August 8, 2022

No.GHB22808e

Product Change Notification
Type of Notification: Change of External View

Table 2.2 Appearance Photo (Example : KHNA30F-24)

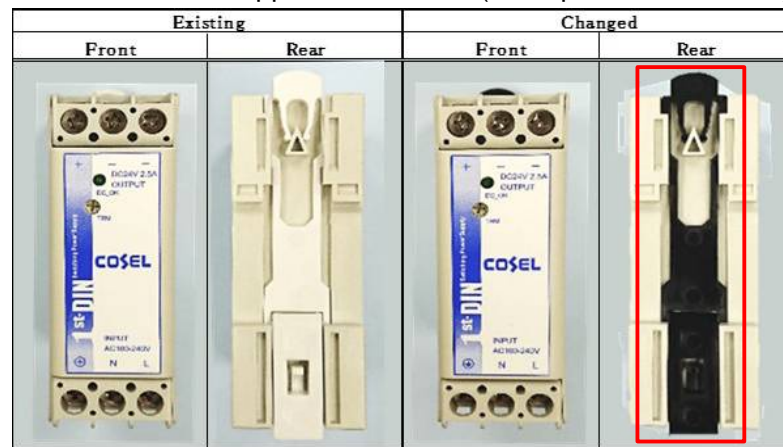
The resin color of the DIN rail mounting lever will change from white to black because of improving the availability of the resin material (See table below). This change does not affect electronic specifications and safety standards compliance.
